EPA Evaluation of the HYDRO-VAC Device Under  
Section 511 of the Motor Vehicle Information  
and Cost Savings Act

August 1983

Test and Evaluation Branch  
Emission Control Technology Division  
Office of Mobile Sources  
U.S. Environmental Protection Agency

HYDRO VAC SYSTEM  
INSTALLATION SCHEMATIC

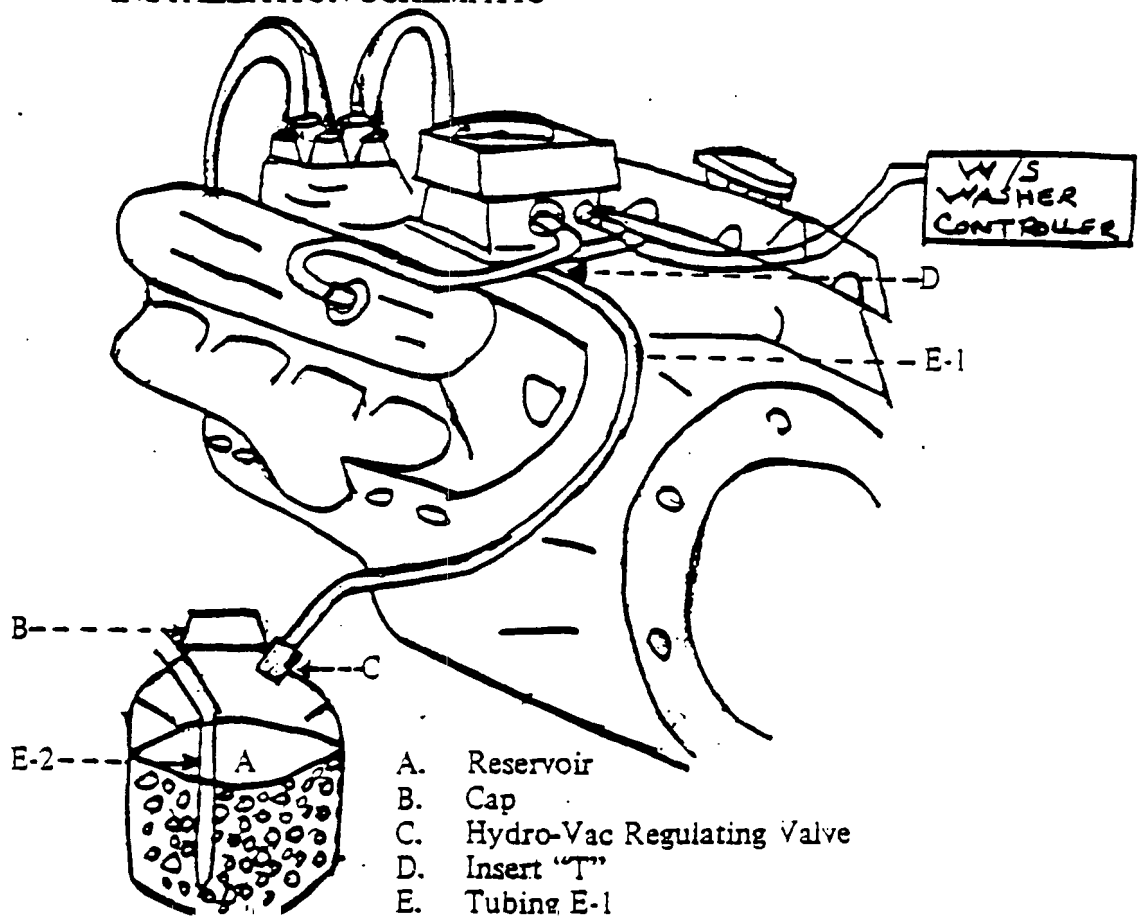
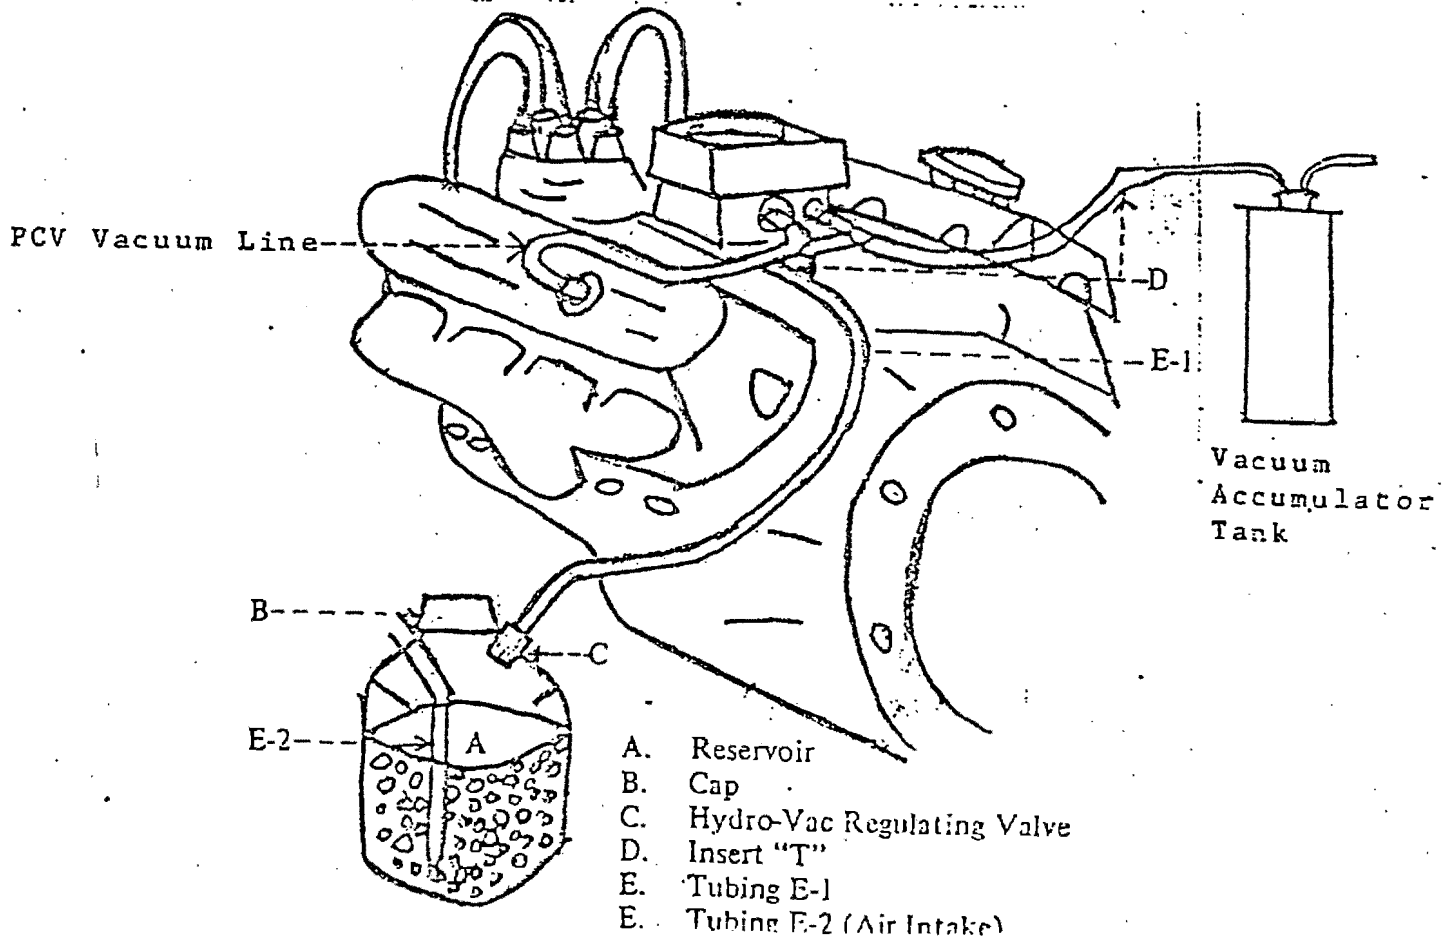
- d. The installation instructions (Attachment B) were not clear as to whether manifold and/or ported vacuum signals should be used to operate the device. Another concern is that the distributor vacuum advance line is suggested as being an acceptable point to tap into for the operating vacuum signal. Because the device does bleed air, it can only weaken the signal sensed by the distributor vacuum advance unit, and consequently the timing will not advance properly. Because vacuum advance can have a significant impact on fuel economy during cruise operation, the device may have an adverse effect on fuel economy benefits for some engines.

Another concern is that a purchaser who locates a vacuum source when the engine is cold, installs the device, and observes bubbles and turbulence in the fluid reservoir (checkout procedure recommended by instructions), may find the device does not function when the engine is at operating temperature. The reason for this is that inline temperature sensors are used extensively on today's engines for purposes of modifying the signal. Thus, it is important the selection of the vacuum line be done when the engine is at operating temperature.

2. You indicate that a source of manifold vacuum is required yet you suggest using the line to the distributor advance mechanism. In most cases, this line supplies ported vacuum. I suggest you revise your instructions to accommodate this inconsistency and provide information on how an air bleed in this line will not upset the calibration of the advance curve.

5. Item 4 of your installation instructions states that after device installation the engine is started and "bubbles and turbulence should be forming in the reservoir," thus indicating the device is functioning properly. Considering that many vehicles incorporate a temperature valve to control the ported vacuum signal to the distributor, it may be that there will be no vacuum to your device while the engine is cold. Of course, this depends on which vacuum line is used for the device. Have you considered this potential problem?

2. In some applications this distributor advance line is a ported vacuum, not manifold. However, on the gasoline powered cars where I installed the Hydro-Vac unit, this vacuum source was manifold vacuum. In no case has it been necessary to re-set the timing because of the Hydro-Vac vacuum line being connected to this distributor advance vacuum line. The Hydro-Vac uses only a small portion of the available vacuum on this line. I am glad you brought this to my attention as I will change the Literature to reflect this.

2. Locate a manifold vacuum line source for best results. The PCV vacuum line or vacuum accumulator tank line is an excellent choice. Suggest before cutting any vacuum line, disconnect the chosen vacuum line while engine is running at idle R.P.M.'s and by holding finger over open end of line, determine for certain you have vacuum. If no vacuum is felt, replace this vacuum line and choose another. After manifold vacuum line is located, cut the line selected and insert the plastic Tee (Fig. D). Cut vacuum tube E-1 to required length and connect to Tee (Fig. D). Secure tubing from moving belts and pulleys and hot areas.
